<b>Information-Request/Submittal/Release</b>		<b>Number</b>	<b>S</b>	<b>038-0012</b>		
<b>Number of attached pages</b>		20	<b>New</b> <input type="checkbox"/>			
<b>Project</b>	MACS		<b>Revision</b> <input checked="" type="checkbox"/>			
<b>Originator</b>	T. D. Pike		<b>If revision, provide the following:</b>			
<b>Date</b>	February 3, 2003		<b>Previous Submittal</b>			
<b>Database Reference</b>	038-2489		<b>ECR/ECN</b>			
<b>Scope</b>						
Specification for the Revised MACS Beam Shutter						
<b>Purpose</b>						
Revised specifications for the MACS Beam Shutter to replace the original failed shutter.						
<b>Description</b>						
Text and images that specify the requirements for the Shutter revision						
<b>Filing</b>		<b>Change Process</b>				
When filed as a submittal, this form and the information attached to it transforms into a released document when it is signed by all parties named in it. The form with attachments is kept on file in the office of the NIST chief engineer. When attachments are electronic in nature (such as electronic CAD data) that information and its hierarchical position in the project design tree shall be identified in or under this submittal. Informati

**Figure A** Section and Details of Revised MACS Shutter Design

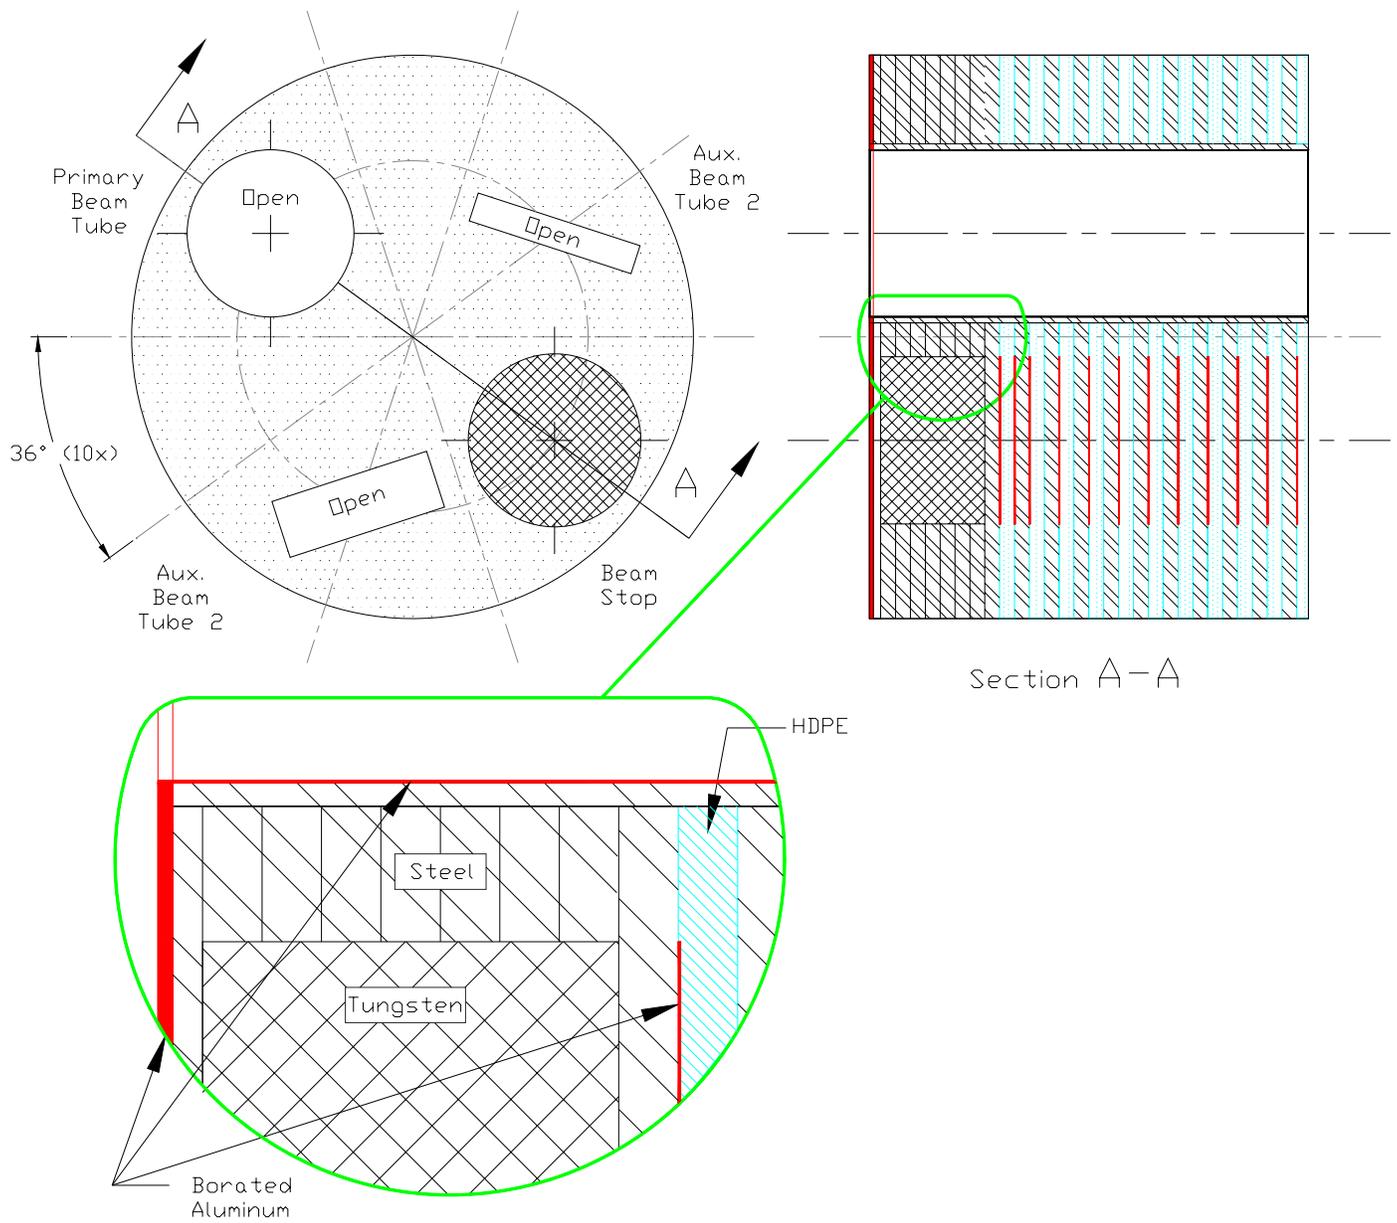
Figure A has been added to illustrate the new Shutter Drum. The Shutter cross-section shows that the Neutron Beam tubes are not tapered in the new Shutter Drum Design. Original Shutter Specification figures, provided for reference, remain numbered from 1 to 9.

The second series (steel and HDPE) has three holes: (1) Full Beam Transmission Tube, (2) 100mm Wide Transmission Tube, (3) 50mm Wide Transmission Tube. In addition, the steel and HDPE disks will have features for accommodating attachment between each other, the axle bearing and, to the Shutter Drum Shell. **See Figure A.**
